## SECTION 5.1 – PROJECT LOCATION

**MUNICIPAL CONSULTATION FORM #1:** *The proposed project has extensive impact on Township infrastructure on Amherst Island and the mainland. The proponent has not provided enough detail in the design and operations plan or the construction plan to be able to assess this impact, and the municipality believes approval of the REA at this juncture is premature until the detail has been provided and assessed by the Township. The primary impact is on Island roads, which do not meet modern standards. Several kilometers of roads are identified as haul routes.*

**APAI COMMENT ON ALGONQUIN RESPONSE:** What “other developers provide in their REA application” is not pertinent to the discussion at hand. Furthermore, the level of detail provided in the DO and CPR do not meet regulatory requirements with regards to water taking, spills and the lack of a Response Plan.

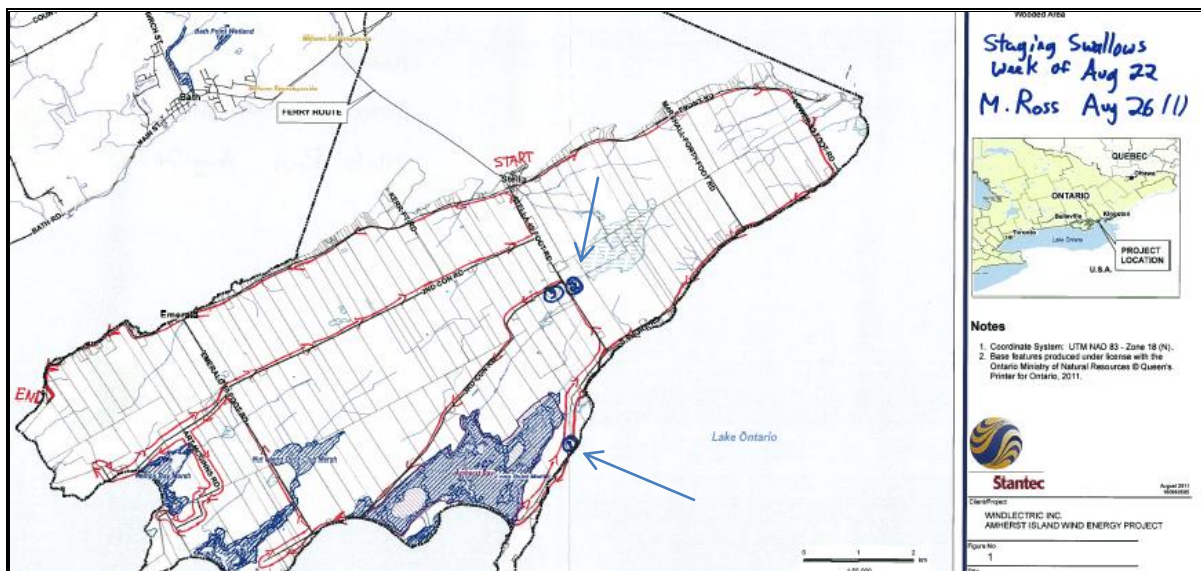
Below is a table which lists the Turbines with suitable ELC classified land within 150 meters of the turbine / Project component. A single “observation stop” is documented in the Field Notes, it occurred on August 16<sup>th</sup> (stop #6).

<b>Turbine within 150 meter of appropriate ELC</b>	<b>ELC Classification abutting</b>	<b>ELC Classification abutting</b>	<b>Comment</b>
S- 31	FOD7-2	CUT1-4	Potential stop #6 - Aug 16 / no stop Aug 26
S-07	FOD7-2	CUM1-1	No stop Aug 16 or 26
S14	FOD7-2	CUM1-1	No stop Aug 16 or 26
S26 / S18	FOD7	CUT1-4	No stop Aug 16 or 26
S04	FOD4	CUT1-4	No stop Aug 16 or 26
S04	FOD9	CUT1-4	No stop Aug 16 or 26
S01	FOD4	CUM1	No stop Aug 16 or 26
S03 / S35	FOD7-2	CUM1	No stop Aug 16 or 26

The Stantec field notes indicate two migratory butterfly surveys which occurred on August 16<sup>th</sup> (4hrs.) and August 2<sup>th</sup> (2 hrs.) in conjunction with Staging Swallow Surveys. Per KFN, Amherst Island’s microclimate means that Monarch Butterflies typically appear on the Island following a strong cold front, (mid-September to mid-October). Butterfly surveys conducted in August would not be expected to record many sightings.

Algonquin states above “The evaluation of significance for Migratory Butterfly Stopover Areas was conducted in accordance with MNR guidelines. The results of which did not find this type of significant wildlife habitat within 120m of the project location.”. Below are maps which seem to indicate otherwise.

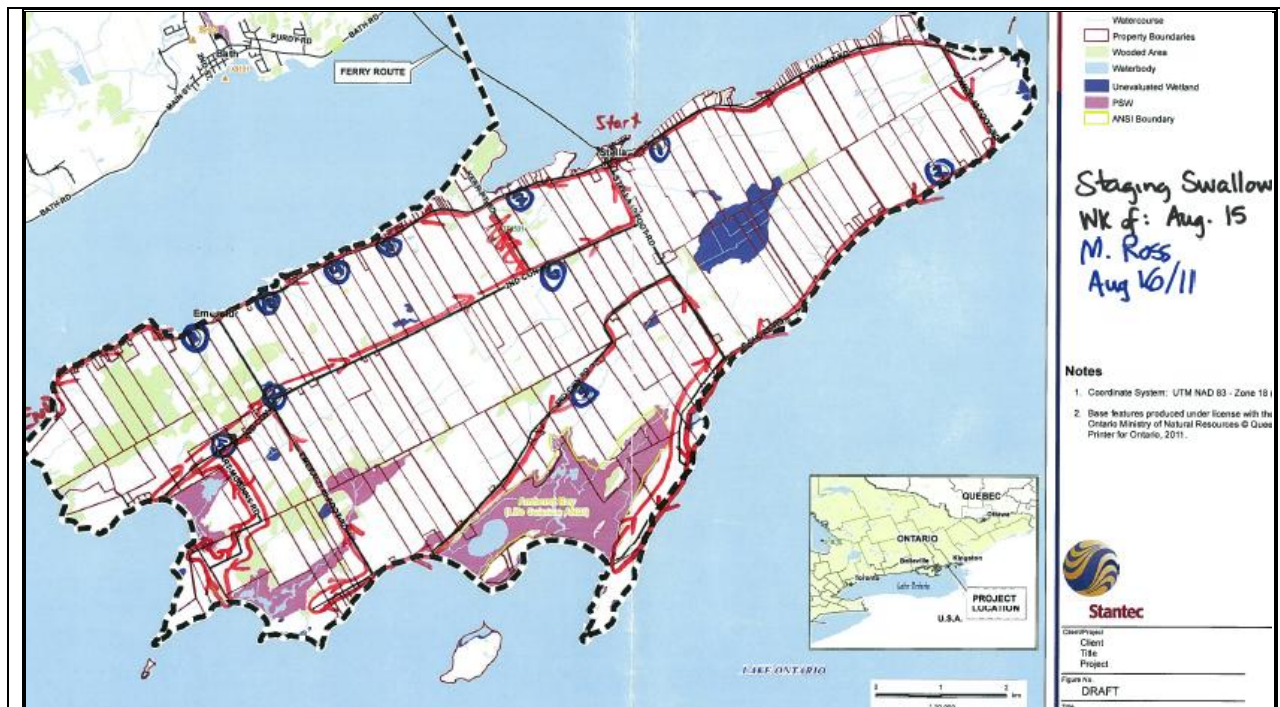
Below is a scan of page 1533 of the NHA/EIS Report. This is a map of the area covered during the 26 Aug 2011 Staging Swallow / Butterfly surveys. The two arrows point to the stops on the survey, notably, nowhere near the Migratory Butterfly Stopover Area. Additionally, the three stops are not in the vicinity of the turbines which are listed in the table above as being located near potential Migratory Butterfly Areas.

Below is a scan of page 1529 of the NHA/EIS Report. This is a map of the area covered during the 16 Aug 2011 Staging Swallow / Butterfly surveys. Again, there are no stops in the vicinity of the Migratory Butterfly Stopover Area. Additionally, the stops are, for the most part, not in the vicinity of the turbines which are listed in the table above as being located near potential Migratory Butterfly Areas.

Algonquin has identified additional suitable habitat in the vicinity of Turbines S31, S07, S14, S26, S18, S04, S01, S03 and S35. However the only migratory butterfly survey that could have occurred in the vicinity of these turbines occurred in the vicinity of turbine S31 on August 16<sup>th</sup>, too early for effective migratory butterfly searches to be undertaken on Amherst Island.

Additional, appropriately timed searches must be undertaken in the Ecoregion 6E specified Candidate Significant Wildlife Habitat which was identified on Amherst Island.
